**Approval for
Phase 3 only at
this time.**

GRANITE RIDGE SUBDIVISION
PHASE 3/4
PART OF THE SOUTHEAST QUARTER OF SECTION 26,
TOWNSHIP 8 NORTH, RANGE 2 WEST,
SALT LAKE COUNTY, UTAH
MILLARD, UTAH
INDEX SHEET

GRANITE RIDGE SUBDIVISION
PHASE 3/4

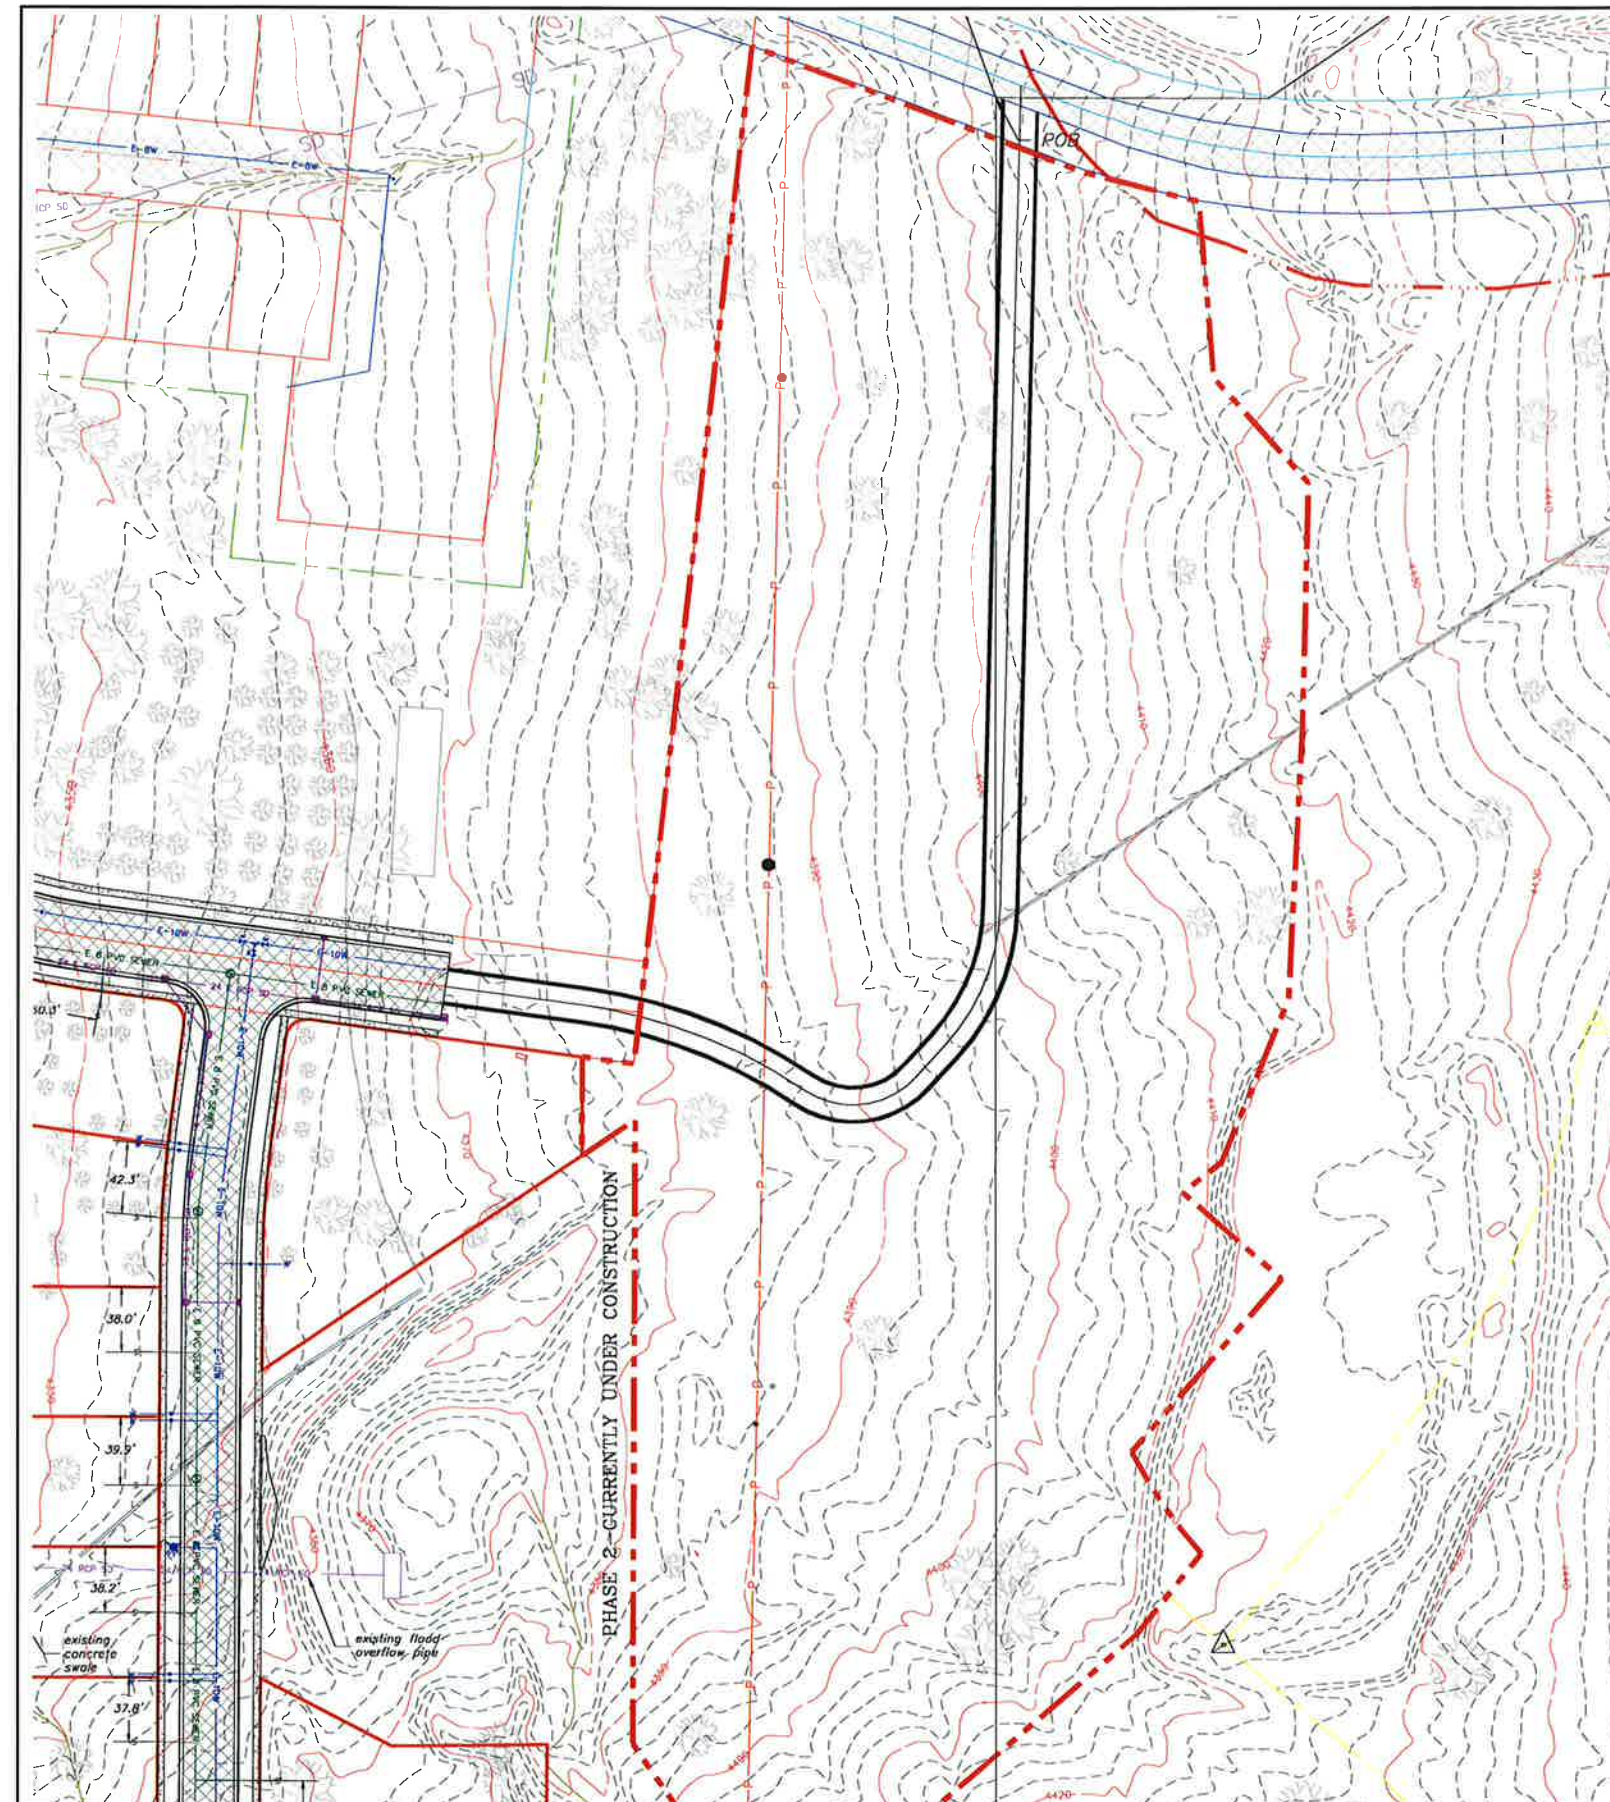
Need additional developer information; i.e.; Company, address, phone numbers.

Valves are to be clustered at tee or cross

GRANITE RIDGE SUBDIVISION
PHASE 3/4
PART OF THE SOUTHEAST QUARTER OF SECTION 26,
TOWNSHIP 8 NORTH, RANGE 2 WEST,
SALT LAKE BASELINE AND MERIDIAN
WILLARD, UTAH
SADDLEBACK ROAD PG1

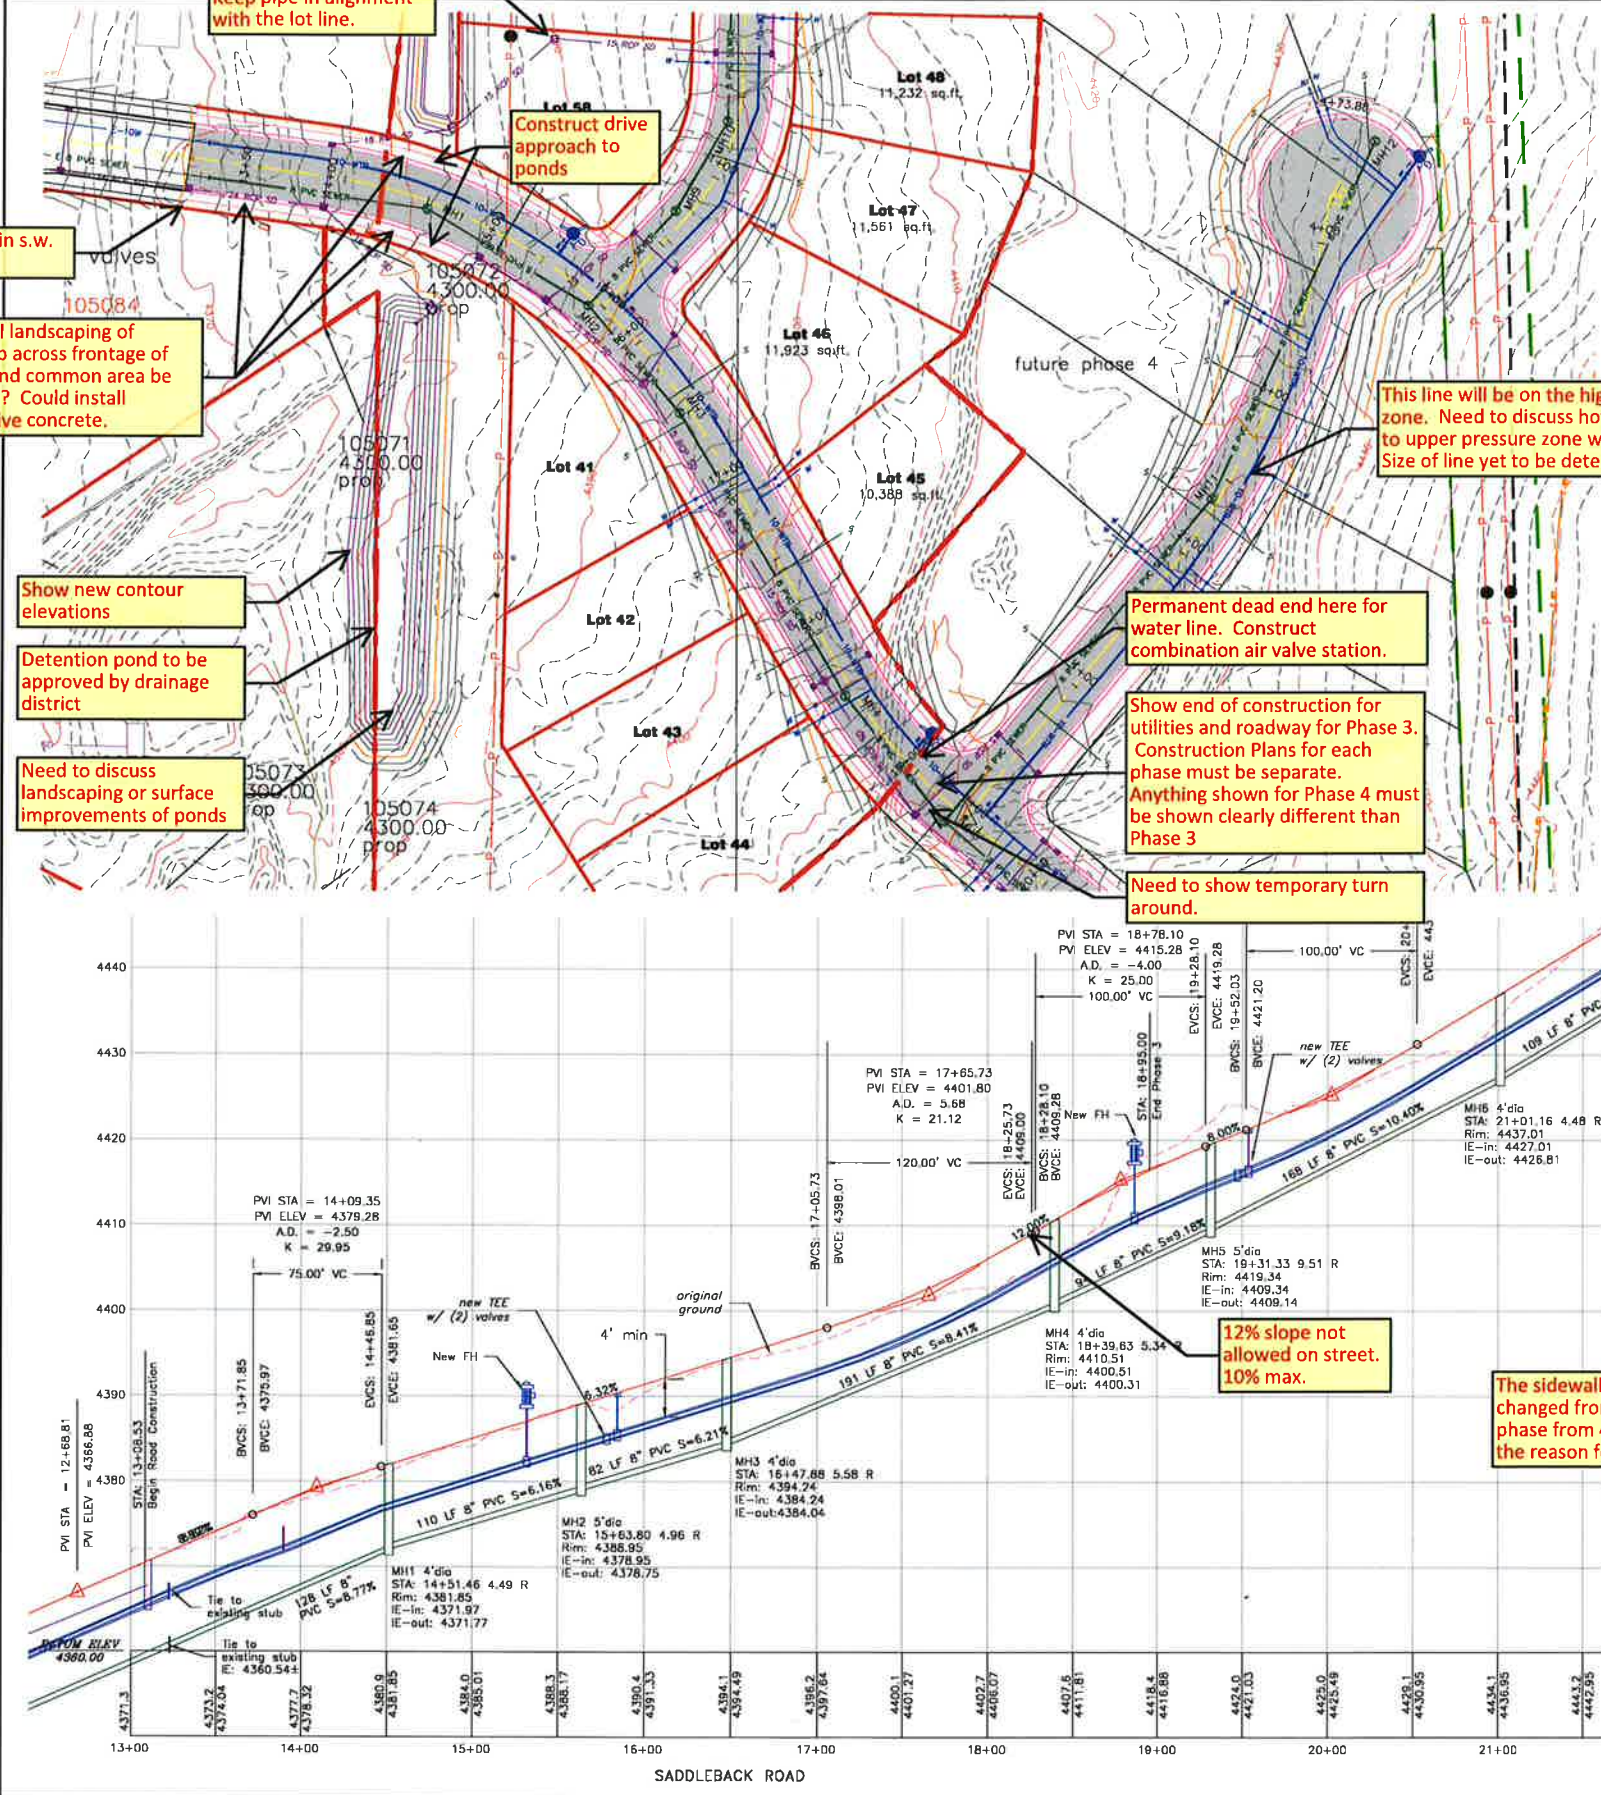
No junction boxes allowed on building lots. Extend pipe directly to detention basin parcel. Keep pipe in alignment with the lot line.

Construct drive approach to ponds

change in s.w. width

How will landscaping of parkstrip across frontage of ponds and common area be handled? Could install decorative concrete.

Show new contour elevations

Detention pond to be approved by drainage district

Need to discuss landscaping or surface improvements of ponds

This line will be on the higher pressure zone. Need to discuss how connection to upper pressure zone will be made. Size of line yet to be determined.

Permanent dead end here for water line. Construct combination air valve station.

Show end of construction for utilities and roadway for Phase 3. Construction Plans for each phase must be separate. Anything shown for Phase 4 must be shown clearly different than Phase 3

Need to show temporary turn around.

12% slope not allowed on street. 10% max.

The sidewalk width has changed from the previous phase from 4' to 5'. What is the reason for this?

TYPICAL ROAD CROSS-SECTION
SADDLEBACK ROAD

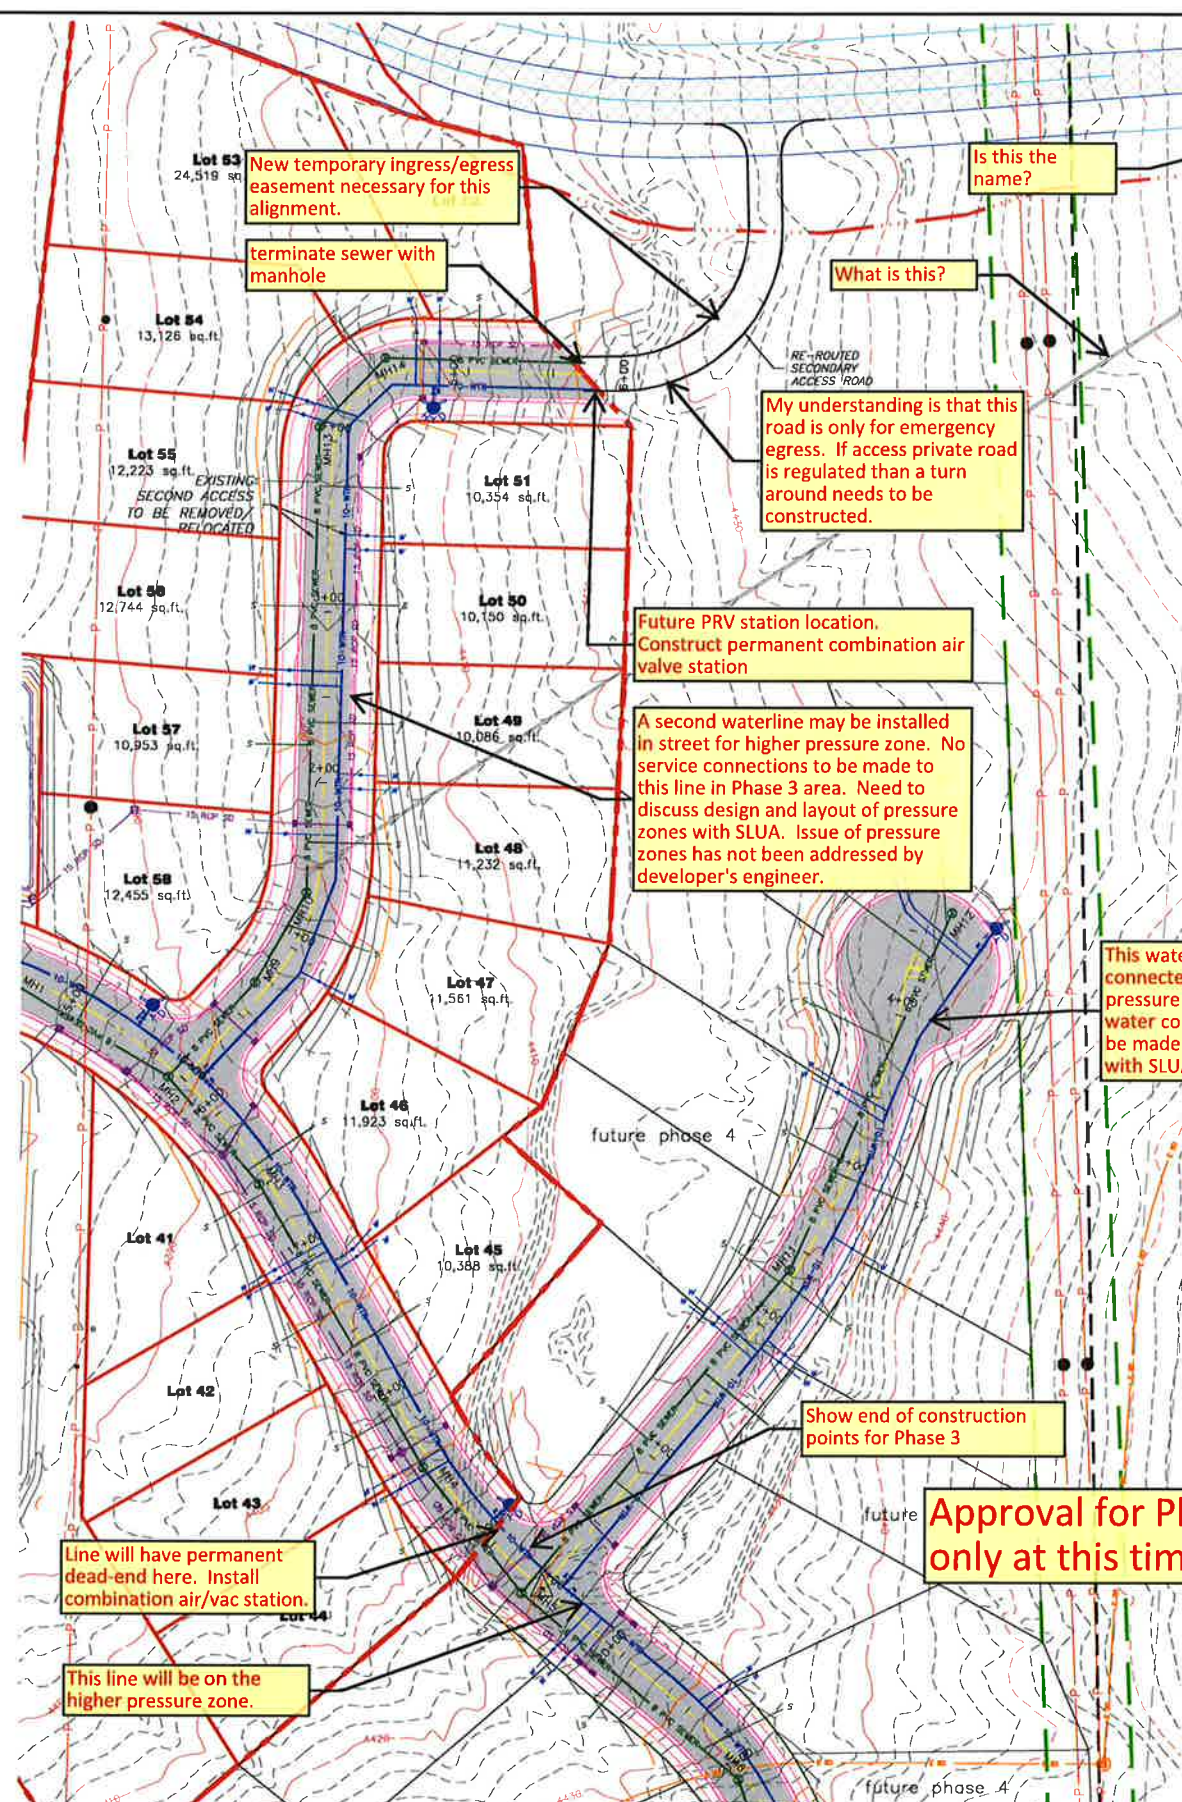
Contractor to apply chip and seal with fog coat after one year

GRANITE RIDGE SUBDIVISION
PHASE 3/4
PART OF THE SOUTHEAST QUARTER OF SECTION 26,
TOWNSHIP 8 NORTH, RANGE 2 WEST,
SALT LAKE BASELINE AND MERIDIAN
WILLARD, UTAH
GRADING/DRAINAGE PLAN PG1

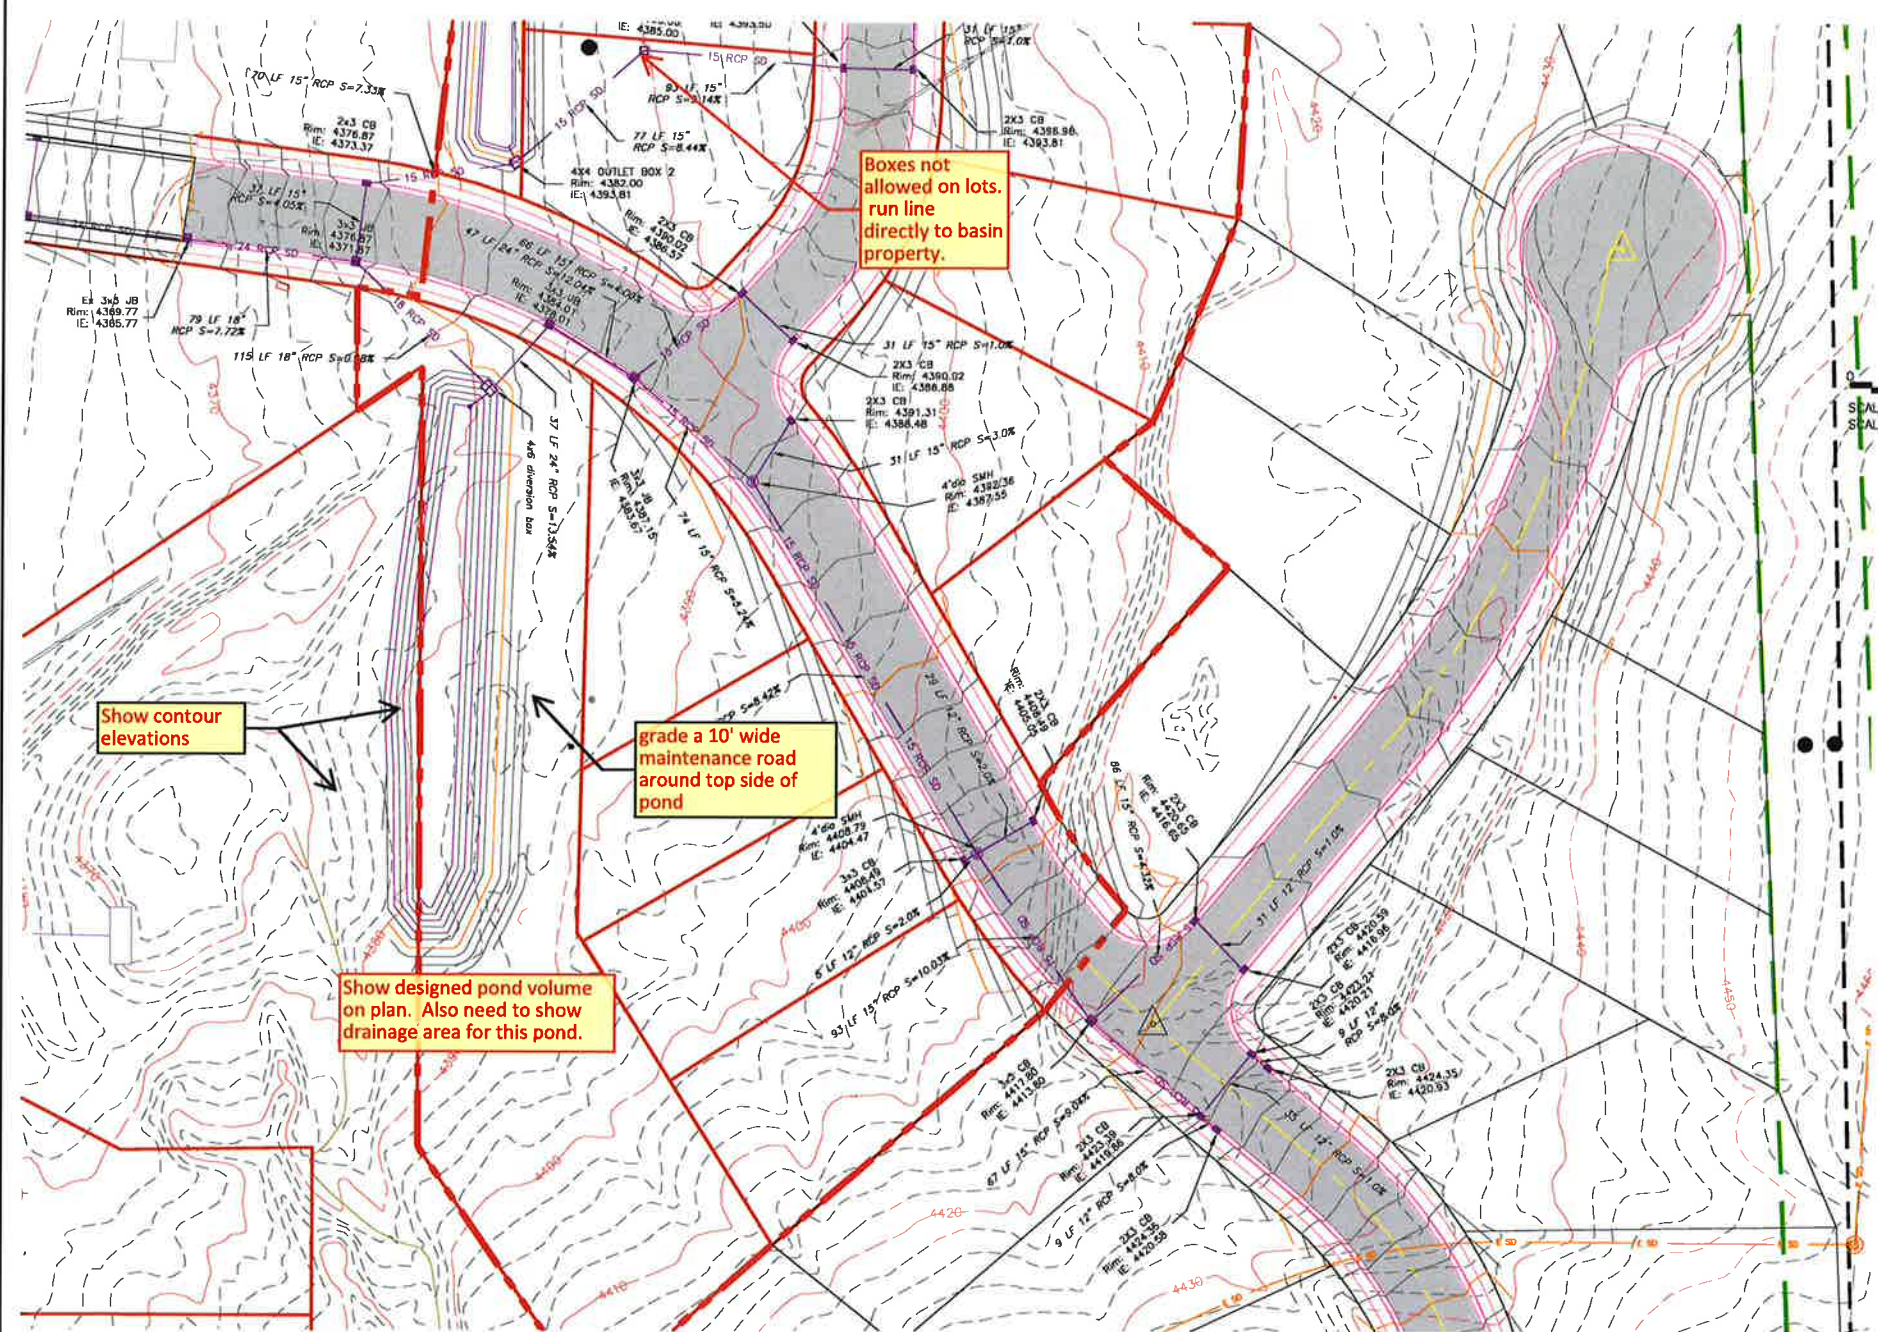
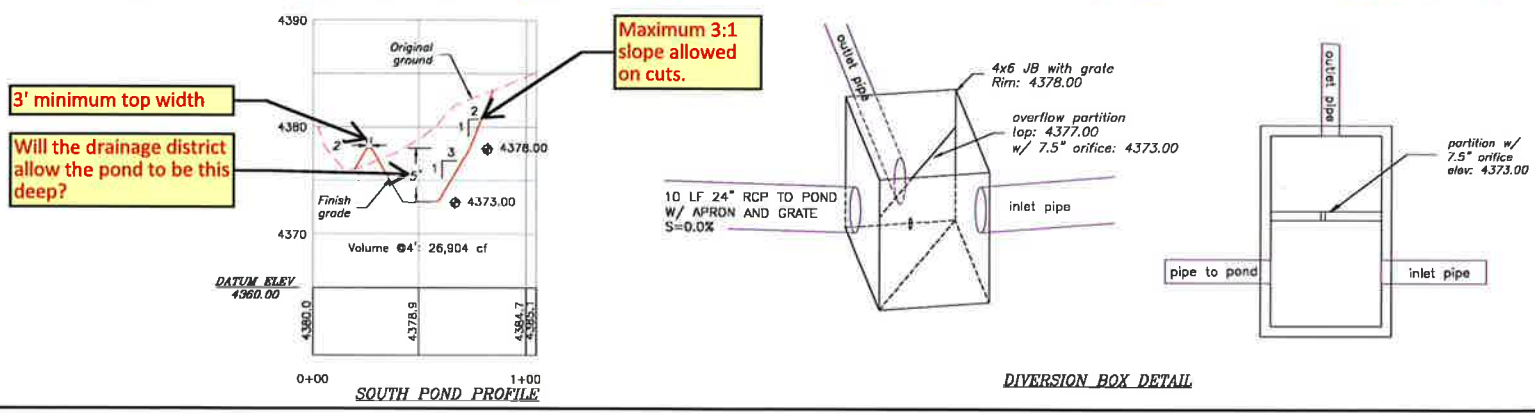
Subject to approval by
Drainage District
